**CALIFORNIA REGIONAL WATER QUALITY CONTROL BOARD
LAHONTAN REGION**

- ITEM:** 4
- SUBJECT:** **ADOPTION OF AMENDED WASTE DISCHARGE REQUIREMENTS; FORT IRWIN NATIONAL TRAINING CENTER, WASTEWATER TREATMENT FACILITY, BOARD ORDER NO. R6V-2004-0005, SAN BERNARDINO COUNTY**

BOARD ORDER NO. R6V-2004-0005-A1-(PROPOSED)
WDID NO. 6B360703001

Amendment to Waste Discharge Requirements – Fort Irwin National Training Center Wastewater Treatment Facility

**Fort Irwin, NTC
Wastewater Treatment
Facility Area
Figure 1-3**

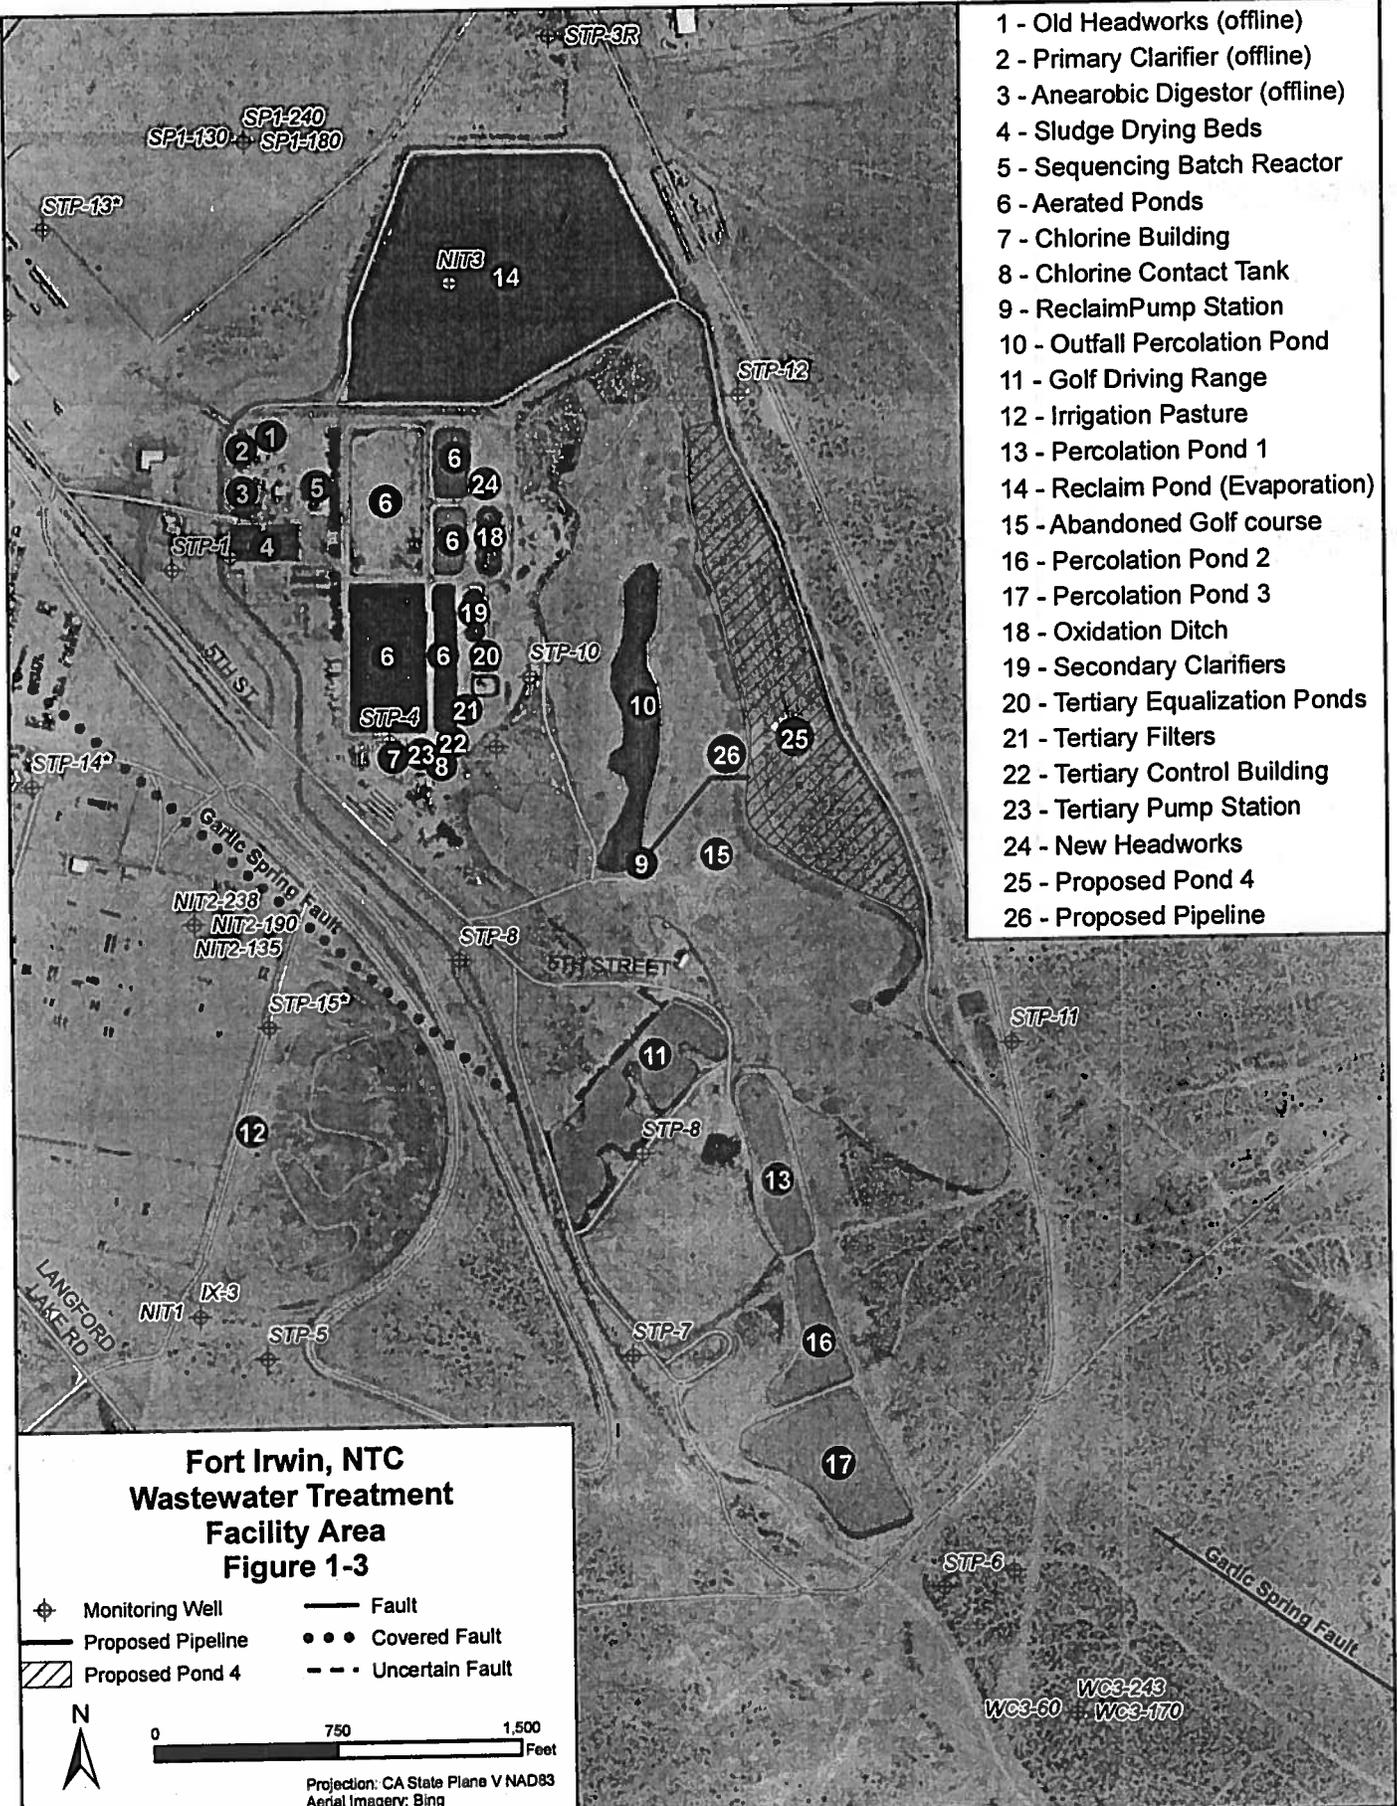
CH2M HILL is hereby requesting the following sites be added to Finding No.9 of Board Order No. R6V-2004-0005. The details of the requested new sites to be added are shown in table 1-1 below. Attachments B and C are requested to replace the current attachments in Board Order R6V-2004-0005.
